IMPORTANT SAFETY RECALL

Subject: Safety Recall Campaign 21V061

Involving: 2021 PJ Trailers - Models C4, U6, U8, UC, UL

SERVICE ALERT BULLETIN

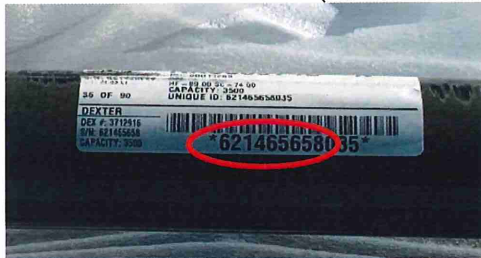
PJ Trailers with idler axles may potentially have hubs missing inner bearing. The suspect axles are labeled with Dexter Axle Serial Numbers: 622463901 & 622463906 attached to the axle tube.

- 1) For specific trailers shown on the list attached, identify the axle serial number by looking at the label attached to the axle (see below defined by first 9 digits):

- 2) If the axle serial number matches the suspect lots (622463901 or 622463906), then evaluate the axle to confirm the presence of the inner bearing by one (1) of the methods below.

- 3) Wheel-end evaluation:
 - a. Axle with idler hub (no wheel attached): grasp the outer diameter of the idler hub and attempt to move the hub inboard and/or outboard parallel to the axle beam. Movement greater than 1/8" should be considered an inner bearing 'non-conforming' hub assembly. There will be a noticeable 'wobble' of the hub on the spindle,
